# Economic and Social Council

## Proposal for the 03 Series of Amendments to UN Regulation No. 137 (Frontal impact with focus on restraint systems)

### Submitted by the Working Party on Passive Safety \*

The text reproduced below was adopted by the Working Party on Passive Safety (GRSP) at its seventy-third session (ECE/TRANS/WP.29/GRSP/73 para. 40). It is based on ECE/TRANS/WP.29/GRSP/2023/20 as amended by annex X to the report. It is submitted to the World Forum for Harmonization of Vehicle Regulations (WP.29) and to the Administrative Committee (AC.1) for consideration at their November 2023 sessions.

Model A

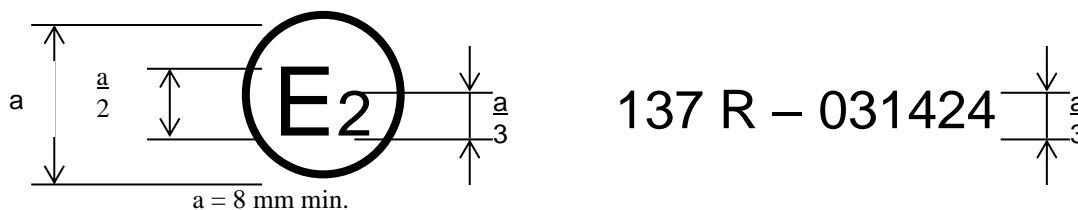
The above approval mark affixed to a vehicle shows that the vehicle type concerned has, with regard to the protection of the occupants in the event of a frontal collision, been approved in France (E 2) pursuant to Regulation No. 137 under approval number 011424. The approval number indicates that the approval was granted in accordance with the requirements of Regulation No. 137 03 series of amendments.

Model B

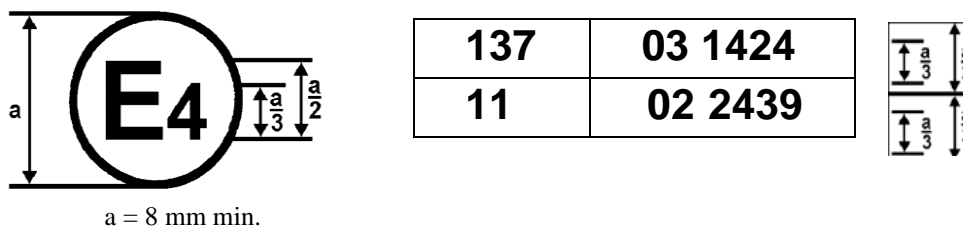
The above approval mark affixed to a vehicle shows that the vehicle type concerned has been approved in the Netherlands (E 4) pursuant to Regulations Nos. 137 and 11.<sup>1</sup> The first two digits of the approval numbers indicate that, at the dates when the respective approvals were granted, Regulation No. 137 incorporated the 03 series of amendments and Regulation No. 11 incorporated the 02 series of amendments.
